THE ILLINOIS STATE TOLL HIGHWAY AUTHORITY

BASE SHEETS

ITS (1000, 1100, 1200, 1300, 1400, 1500, 1600, 1700, 1800, 1900, 2000, 2100, 2500)

Illinois Tollway Base Sheet Revisions		
Section M	**Base Sheet Drawings**	
	Drawing	**Modification Summary** **Effective: 03-01-2026**
	Pole Assembly (ITS)-Series 1000	
	NOTE	NO CHANGES

VERSION:	BASE SHEET:	SHEET:
2026-03	M-ITS-1201	1 OF 1

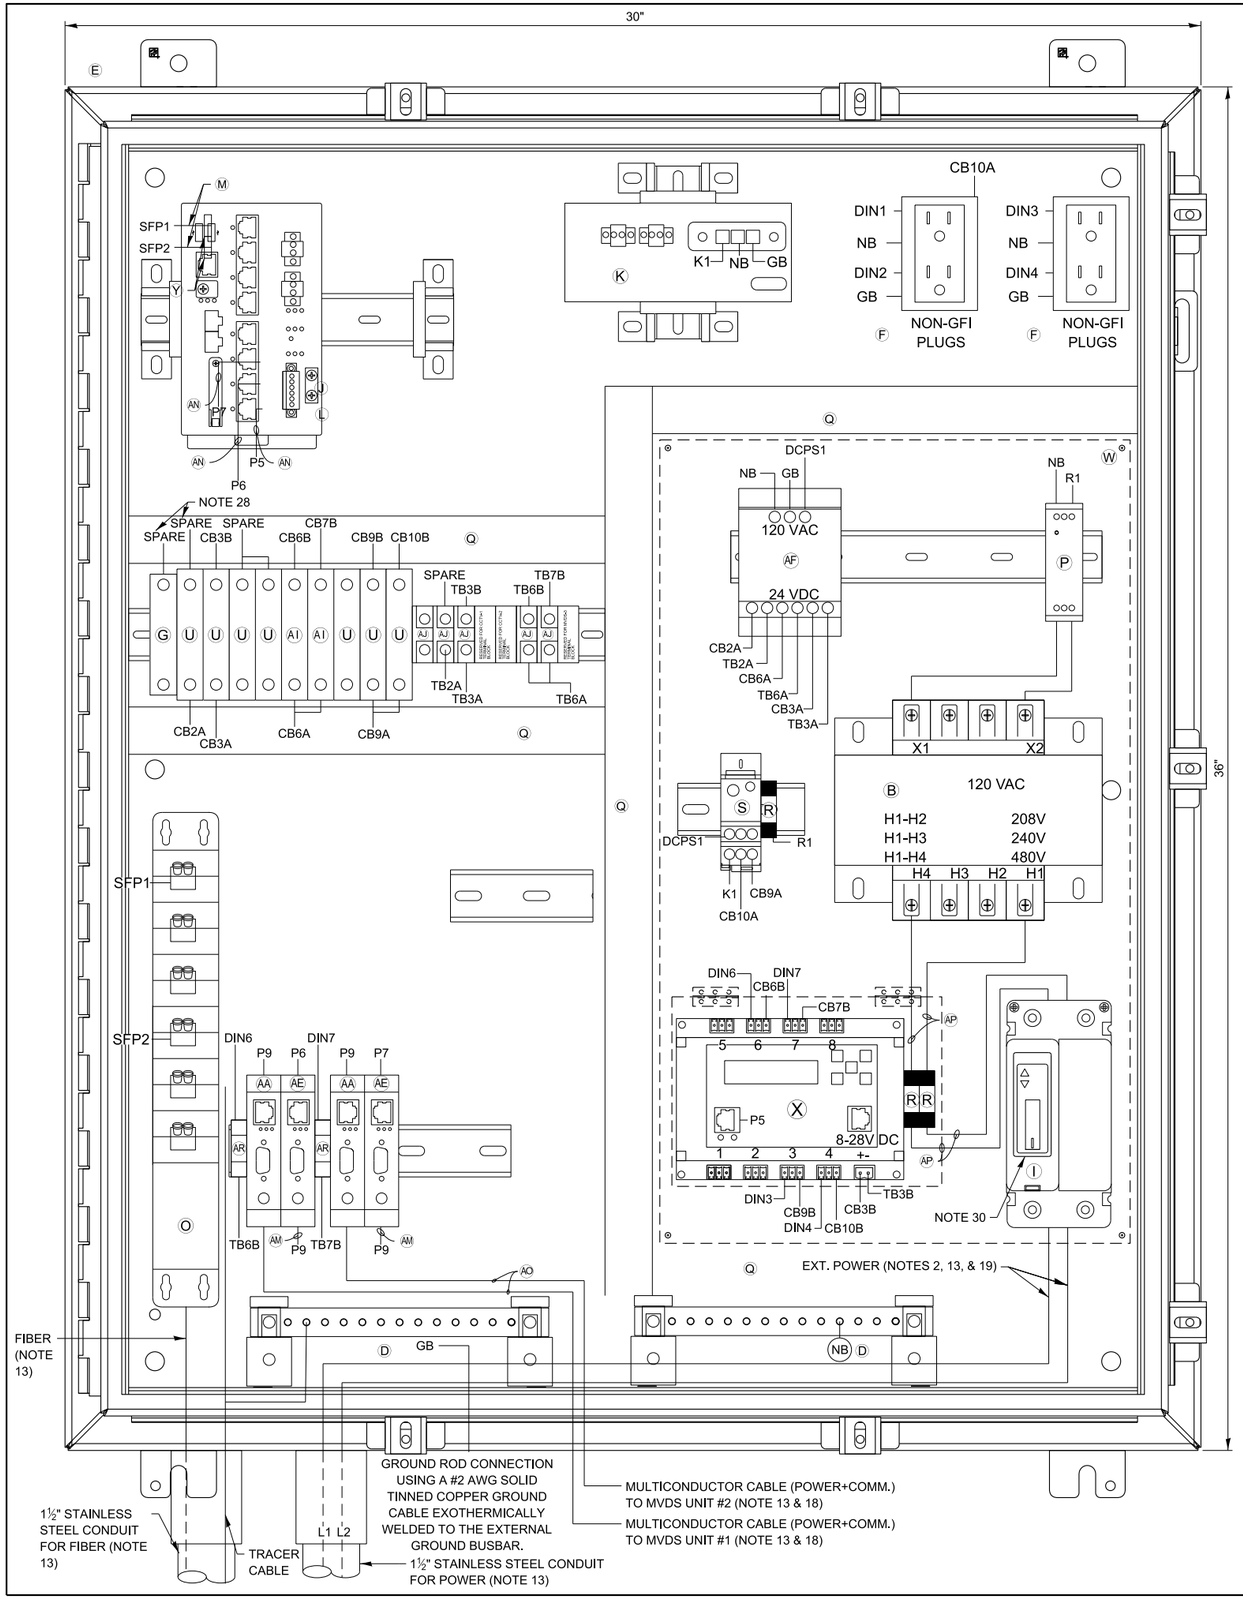
Sheet 1	Replace GFI plugs by Non GFI plugs and identify top power outlet as DIN 1 and bottom power outlet as DIN 2
		Removed space for two spare DC power supplies
		Removed space reserved for two surge suppressors and one PoE power injectors
		Removed space reserved for two MVDS surge suppressors
		Installed spare 5A breakers as part of breaker terminal
		Changed designation of HOT 3 terminal block to CB10A
		Replaced the word Gator Patch by Fiber Patch Panel in Note 13
		Added Note 31: PoE power cable shall be free standing from PoE to power outlet
		Added Item AS: not used for this sheet application
	M-ITS-1201	**Cabinet Layout and Wiring ITS Pole Mounted Enclosure (2-MVDS)**

RWIS POLE MOUNTED ITS CABINET WIRING DIAGRAM

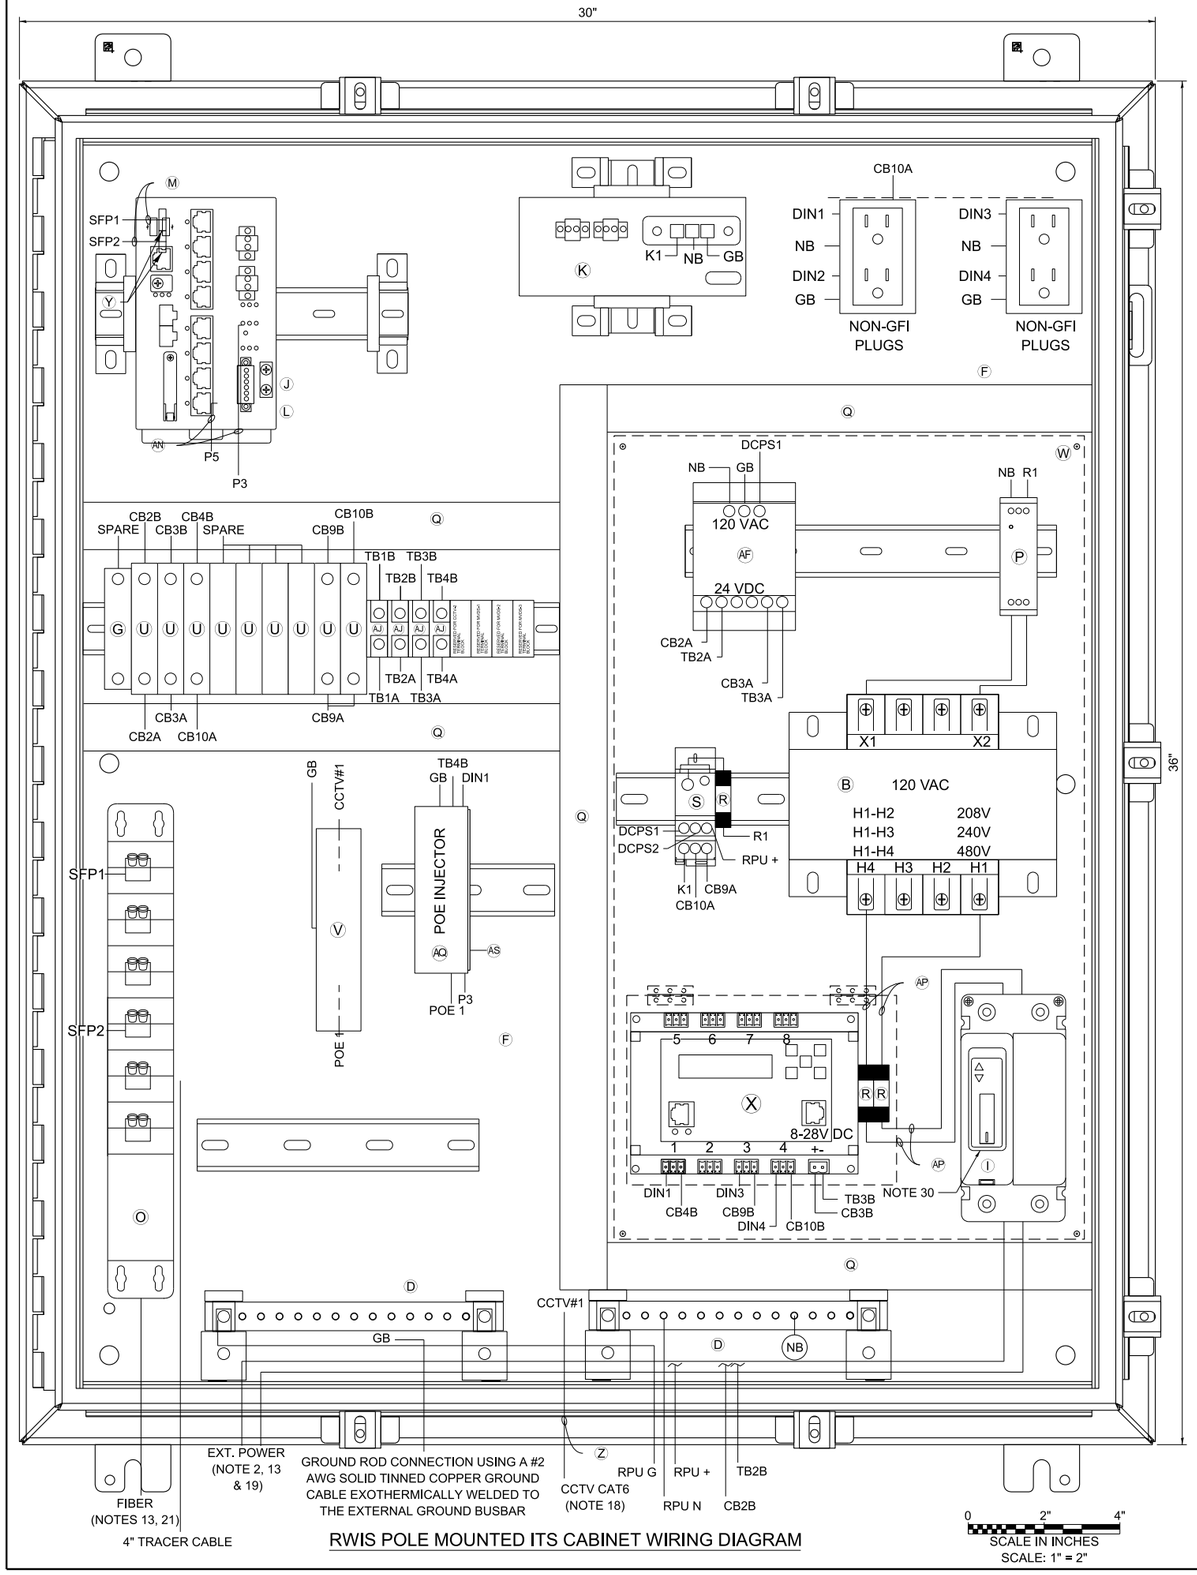
Section M	Base Sheet Drawings	
	Drawing	**Modification Summary** **Effective: 03-01-2026**
	Roadway Weather information System (ITS)-Series 1300	
	M-ITS-1301	**RWIS Cabinet Wiring Diagram**
	Sheet 1	Replace GFI plugs by Non GFI plugs and identify top power outlet as DIN 1 and bottom power outlet as DIN 2
		Remove two spare DC power supplies
		Removed space reserved for one surge suppressor and one PoE power supply
		Installed spare 5A breakers as part of breaker terminal
		Changed designation of HOT 3 terminal block to CB10A
		Added Item AS as Axis T91A03 DIN Rail Clip B
		Item AQ PoE power injector changed to Axis TU8003 90W Midspan 120VAC
		Replaced the word Gator Patch by Fiber Patch Panel in Note 13
		Added Note 31: PoE power cable shall be free standing from PoE to power outlet

CONTROL BUILDING MAIN TOLL PLAZA EQUIPMENT LAYOUT

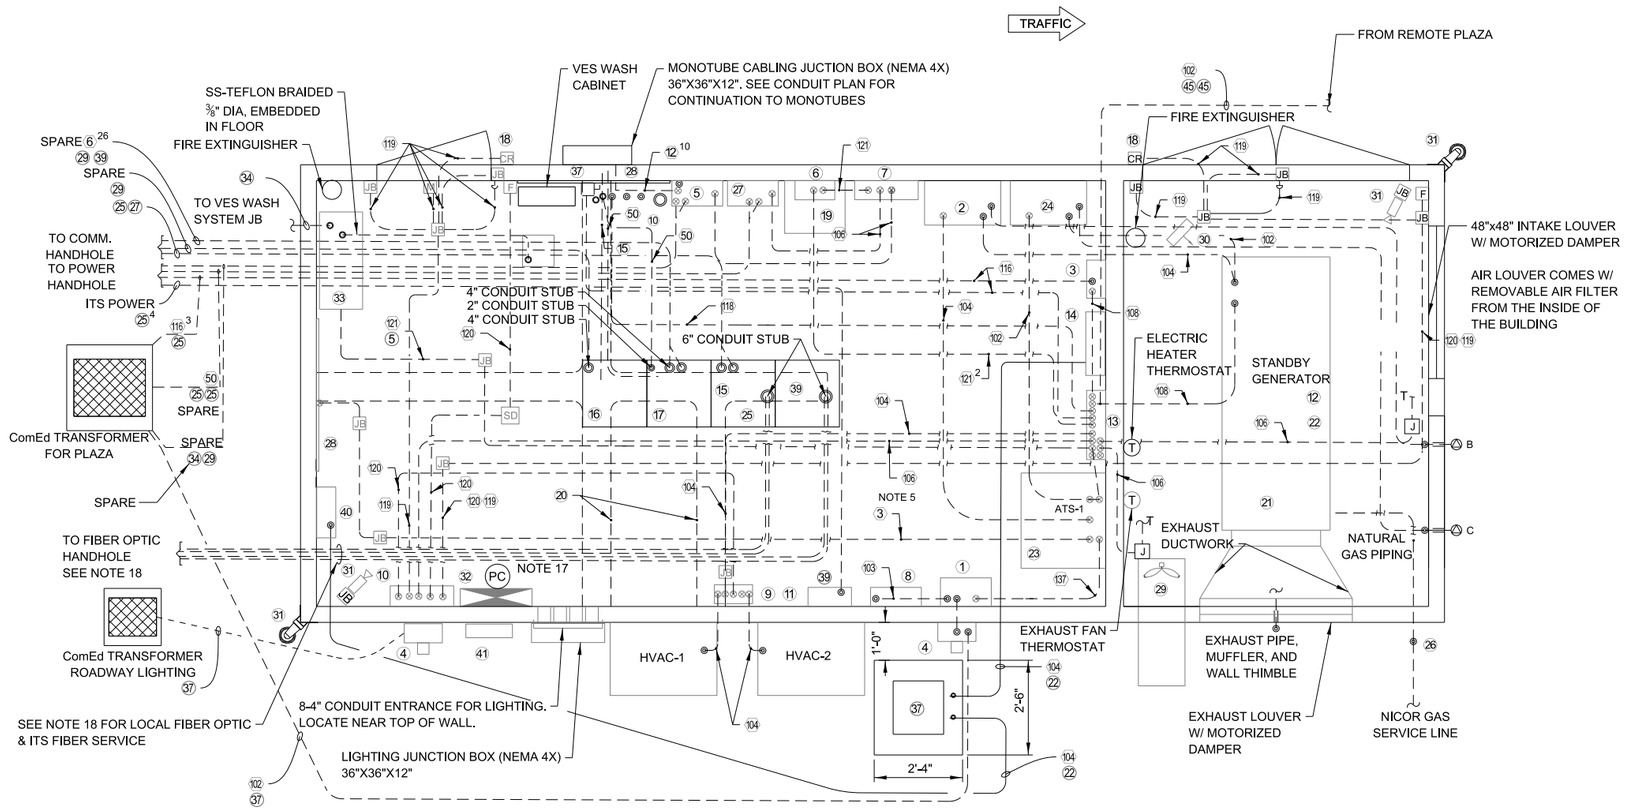
Sheet 1	Added a clearance of 18 in between HVAC 1 and HVAC 2
	M-BUS-2510	**Control Building Equipment Layout - Main Plaza**
	Sheet 1	Connected loose conduit to ITS Panel 1-2 ITS (Item 39)
		Tag 38 was incorrectly identified as Tag 38 but shall be identified as Tag 37 as 5KVA transformer

VERSION:	BASE SHEET:	SHEET:
2026-03	M-BUS-2518A	1 OF 1

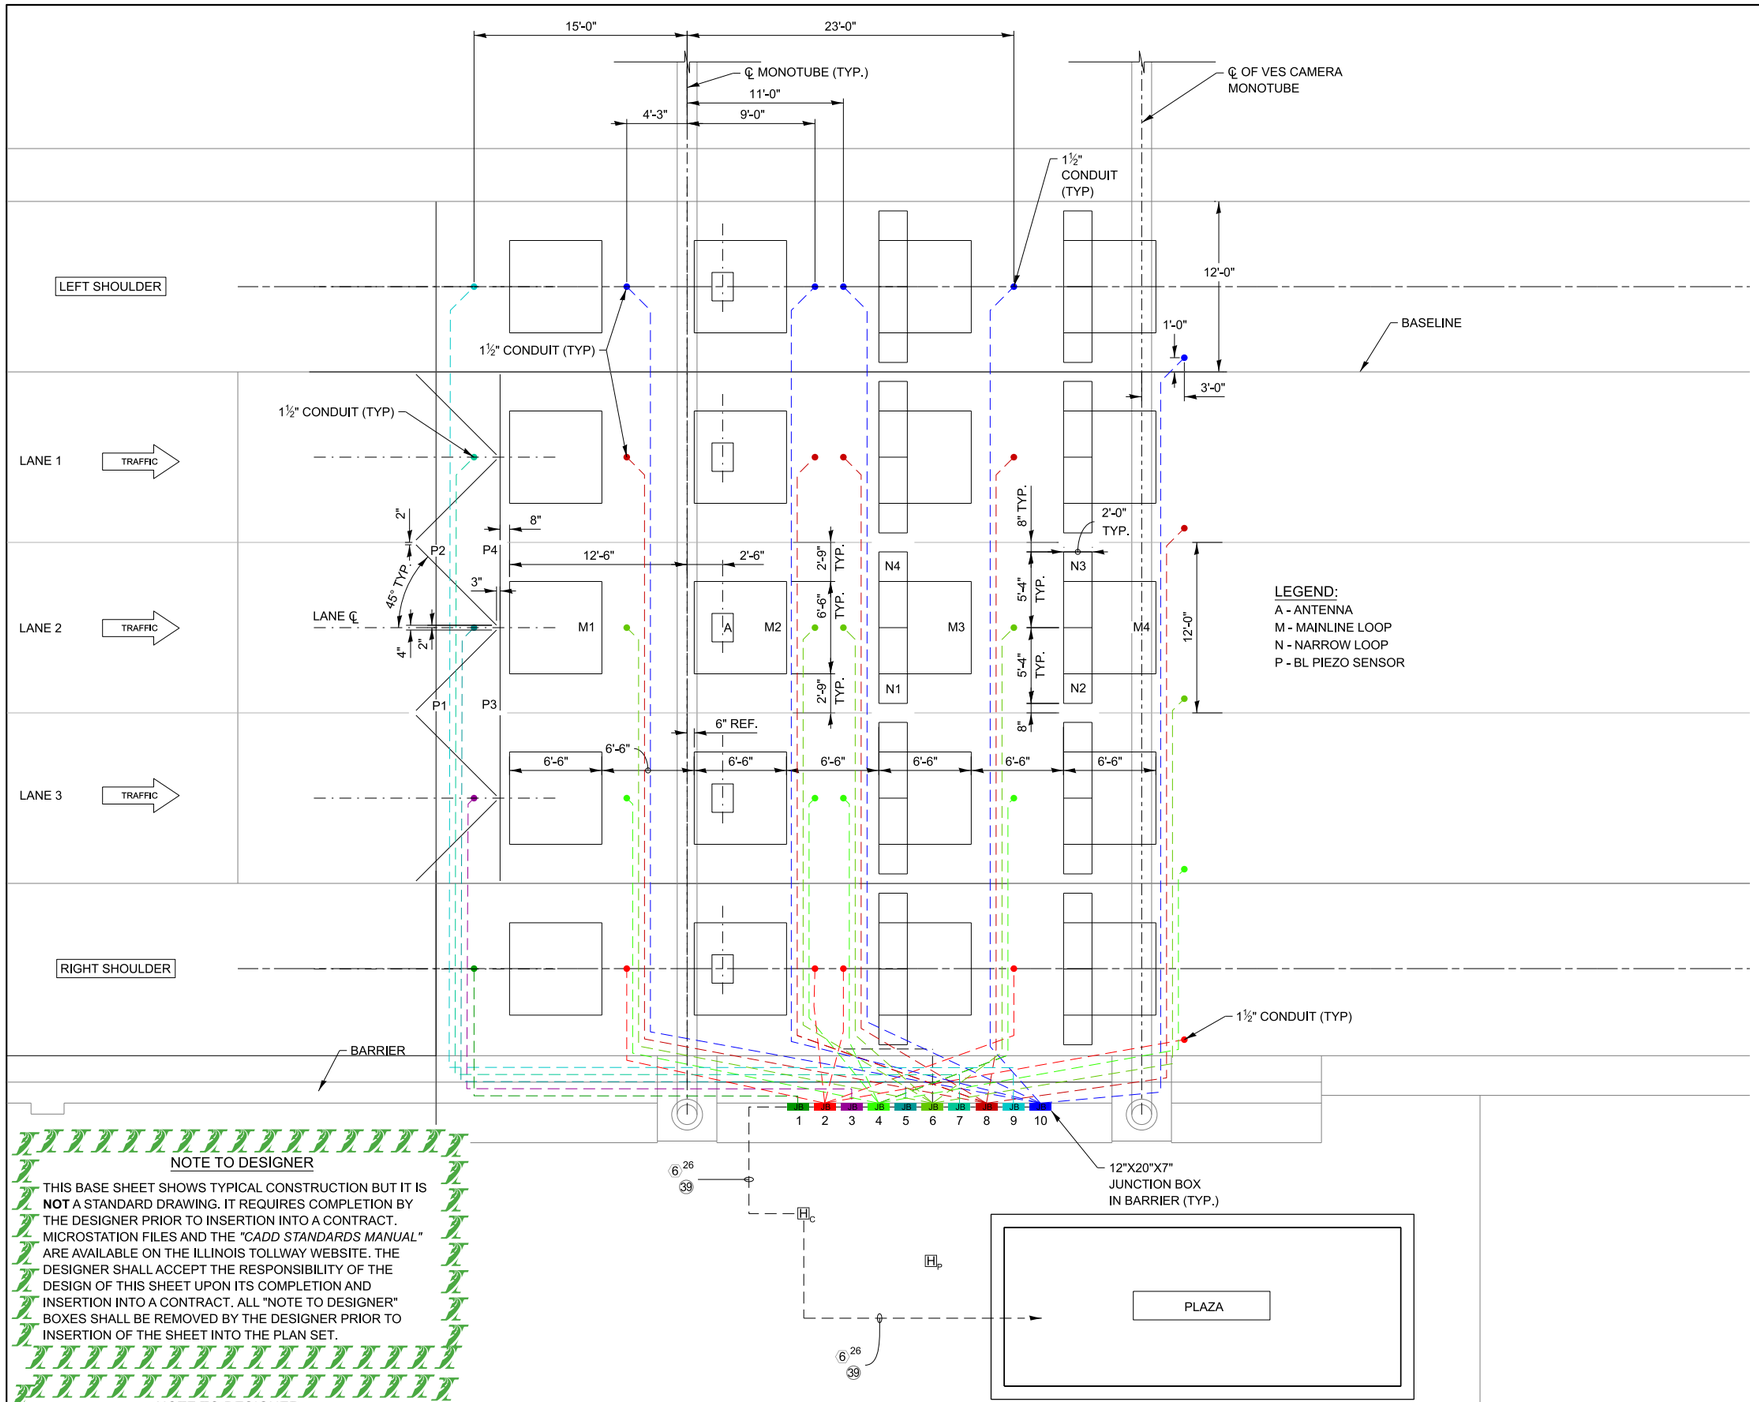
Sheet 1	Revised to add details for "Typical Termination of Spare Underground Conduit"
	M-BUS-2518C	**Loop Plan - AET 1-Lane Layout Single Monotube**
	Sheet 1	Drawing revised to show the installation details for a mounting box to be installed at the top of the vertical segment of the monotube
		For VES Wash conduit: conduit to be one continuous piece when embedded - no splice allowed
		Revised size of 1" to size 1 1/2" PVC coated RGS conduit
	M-BUS-2518D	**Ground Mounted VES Camera With VES Wash Tubing**
